Process Sheet

Customer : CU-DAR001 Dart Helicopters Services	Drawing Name : PLUG
Job Number : 47473	
Estimate Number : 12337	
P.O. Number :	Part Number : D34923
This Issue : 24/04/2009 S.O. No. :	Drawing Number : D3492 REV C
Prsht Rev. : NC	Project Number : N/A
First Issue : / / Type : MACHINED PARTS	Drawing Revision : C
Previous Run : 46766	Material :
Written By :	Due Date : 30/04/2009 Qty: 40 Um: Each
Checked & Approved By : <u>JUD 09-04-24</u>	
Comment : Est Rev: A 06.03.21 New Issue JLM Est Rev: B 06-08-28 As per Rev B JLM Est Rev: C 07-12-06 Rev C dwg DD verified by: EC Est Rev: D 08-05-07 add note to count qty DD verified by: JLM Est Rev: E 09-02-18 remove o'ring DD

DRAWING NO. D3492	TITLE PLUG	REV: C	DART AEROSPACE LTD ENGINEERING ORDER		D.E.O. NO. D3492-C-1	SHEET NO. SHEET 1 OF 1	SCALE NTS
DRAWN AJS	CHECKED	MFG. APPR.	APPROVED		DE APPR.		
DATE 08.11.05	DATE 08.11.05	DATE 08.11.05	DATE 08/11/05		DATE 08/11/05

D3492-XX PLUG MACHINING DETAILS

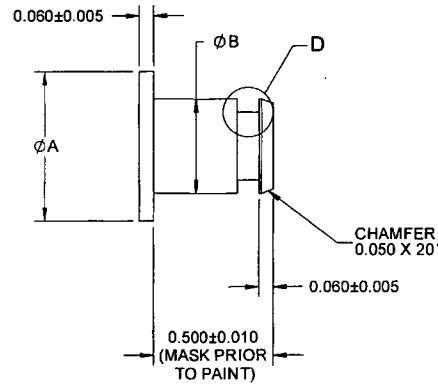
SHEET 2 MODIFY -13 PLUG AS SHOWN:

WAS:

D3492-XX PLUG MACHINING DETAILS

P/N	A	B	C	MATERIAL SPEC
D3492-13	0.750	0.520	0.045	M6061T6R0.750

IS:

P/N	A	B	C	MATERIAL SPEC
D3492-13	0.750	0.510	0.045	M6061T6R0.750
